Bicycling and On-Street Parallel Parking

with Critiques of 2 Related Documents

Appendix A. Critique of *An Evaluation of Bike Lanes Adjacent to Motor Vehicle Parking*.

Appendix B. Critique of Bike Lane Design Guide.
<http://www.bicyclinginfo.org/de/bikelaneguide.htm>

Figure 4. Hollywood Blvd.

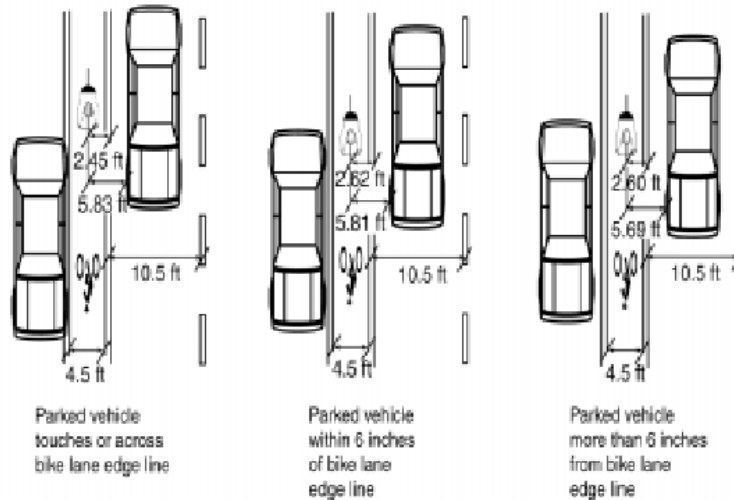
Figure 4 shows that the parking lane is quite narrow at approximately 6-7', not much wider than the parked vehicles or the 5' BL. A1A is similar. Apparent too is that most of the BL is within the so-called “Door Zone” of the parked vehicles since a typical door extends 3-3.5'. Thus, since bicyclists typically position themselves in the center of the BL (also confirmed by the study), they are at risk of being struck/striking a suddenly opening door.

Figure 5. Spacing distances.

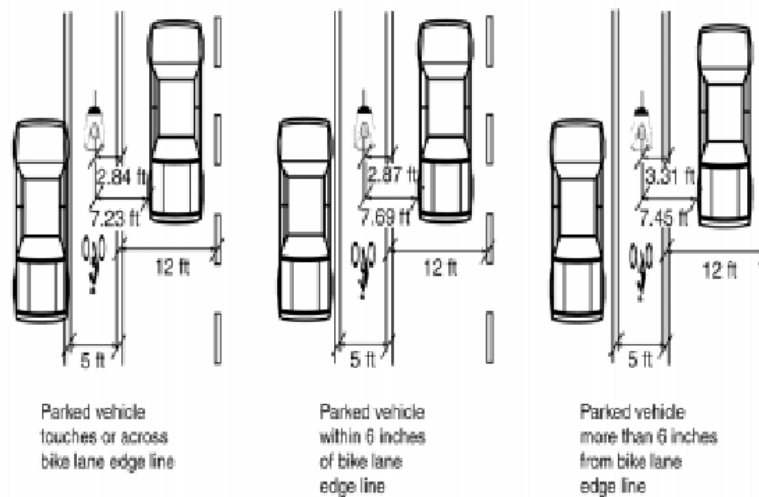
The actual spacing distances are shown below in Figure 5. The BLs are 4.5' wide (inside to inside) at A1A and 5' at Hollywood Blvd, and the adjacent lane widths are 10.5' and 12' respectively. Parking lane widths are not given. As can be seen in Figure 5, a condition “Parked vehicle touches or across bike lane edge line” occurred. The report does not specify the extent of this encroachment on the BL, nor does it give the distribution of parked vehicles or bicyclists riding under the other two parking distance conditions, “Parked vehicle within 6 inches of bike lane edge line,” and “Parked vehicle more than 6 inches from bike lane edge line.”

Figure 6. A drawing from the Guide, modified by the removal a Bike Lane stripe.

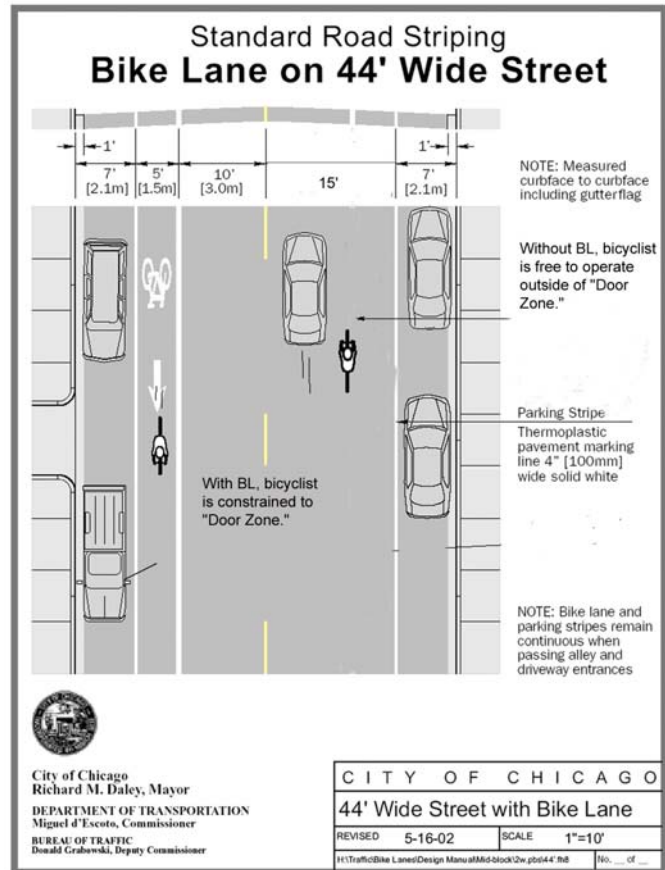
Figure 6 shows a typical drawing from the Guide. I have modified the drawing by removing a BL stripe and adding the commentaries “Without BL, bicyclist is free to operate outside of “Door Zone,” and “With BL, bicyclist is constrained to ‘Door Zone.’”

Also in Figure 6, the parking lanes are 7' wide, just slightly wider than a typical passenger vehicle. Thus, an open door must extend into the BL, as is depicted.

The City of Chicago Department of Transportation created the drawings. Surely the attendant engineers realized that the BLs do not afford sufficient lateral clearance to the parked vehicles, and that a potentially suddenly opening door extends into the BL, creating an obstruction and hazard in the traveled way of bicyclists. The reviewers at the Pedestrian and Bicyclist Information Center, the Association of Pedestrian and Bicycle Professionals, and the Chicagoland Bicycle Federation should also have realized the inherent hazard the designs in the Guide create.
